UNITED STATES PATENT AND TRADEMARK OFFICE

10/824,124

John F. Shanley

DETAILED ACTION

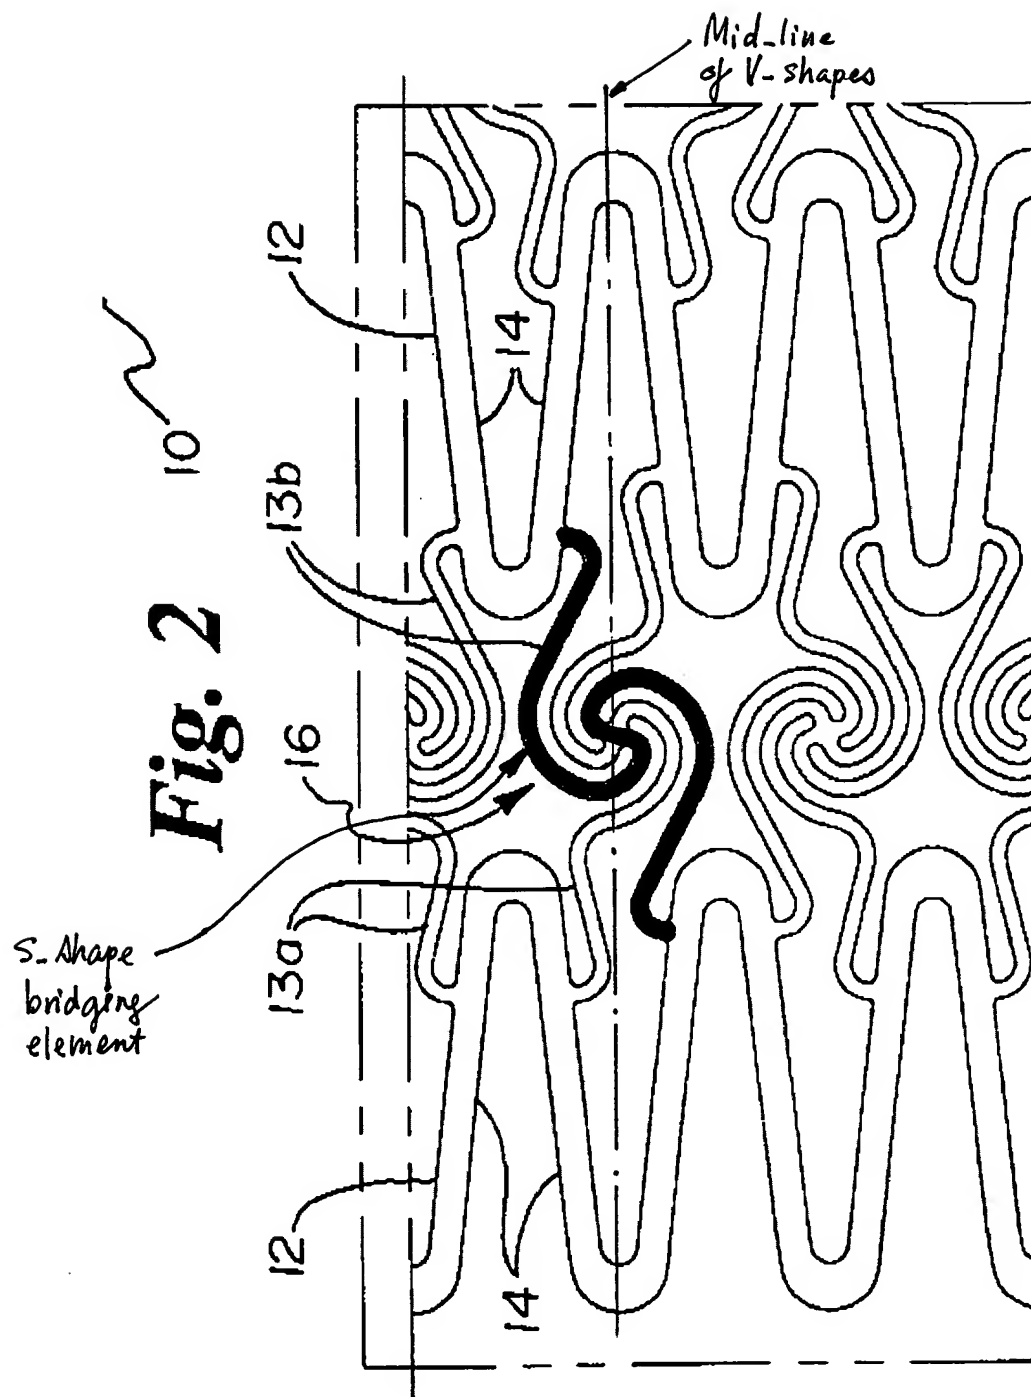
Claims 1-9 are rejected under 35 U.S.C. 102(e) as being anticipated by Her et al- 6,033,433.

As to claims 1-9, Ehr-'433 (please refer to Fig. 2 reproduced on next page) discloses a stent having S-shape bridging elements crossing three times midlines of V-shapes as recited in the claims.

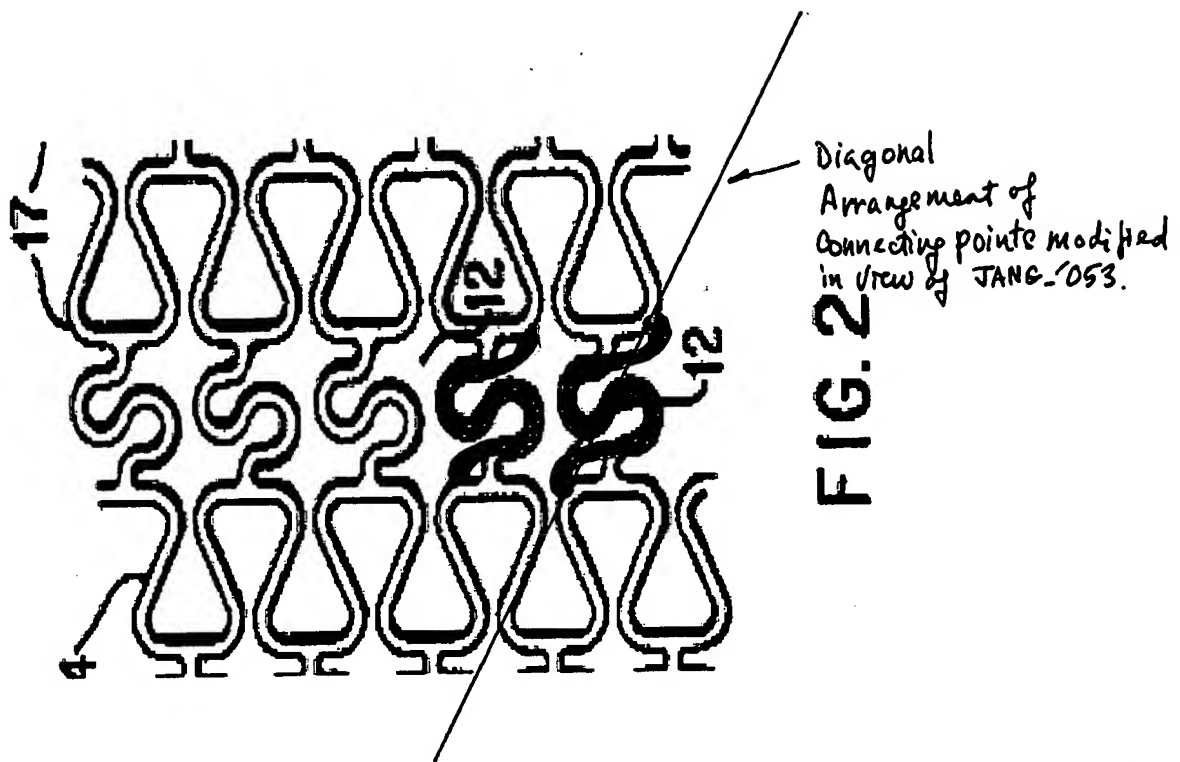
Claims 10-16 are rejected under 35 U.S.C. 103(a) as being unpatentable over Fischell et al.-5,697,971 in view of Jang-6,235,053.

Fischell-'971 (Figs. 2-3) discloses a stent 10 having cylindrical tubes having adjacent struts and S-shaped bridging elements substantially as recited in the claims, except for the connecting points of the S-shaped bridging elements located diagonally and bridging element less wider than strut as recited in the claims. However, Jang-'053 (please refer to Fig. 2 above) discloses connecting points of the S-shaped bridging elements located diagonally and S-shaped bridging elements less wider than adjacent struts. It would have been obvious to one of ordinary skill in the art at the time of the invention to move the connecting points to the locations as shown in modified Fischell-'971 stent in view of Jang-'053 (please, see Fig. 2 on next page) for this modified configuration is just another choice of design for Fischell-'971 stent in view of Jang-'053.

The arguments asserted that the modification of Fischell-'971 in view of Jang-'053 was improper because the combination of Fischell-'971 and Jang-'053 do not teach the claimed invention, especially when the modification is achieved by replacing S-bridge of Fischell-'971 with straighter S-bridge of Jang-'053, and when doing so, the cells 12 of a modified Fischell-'971 stent in view of Jang-'053 will block a branch artery.

In response, the examiner would like to assert that the modification as suggested in the previous "Office Action" did not replace a Fischell-'971 S-bridge for a straighter Jang-'053 S-bridge as asserted by the applicant's suggestion. The modification in the previous "Office Action" suggested a modification of the locations of the connections between a Fischell-'971 S-bridge to the struts to modified locations as taught by Jang-'053, this modification will not block a branch artery against Fischell-'971 teaching, but in fact even give more room for cells 12 to expand for a branch artery, because the modified Fischell-'071 S-bridges in view of Jang-'053 are now longer and have more stored length for expansion.
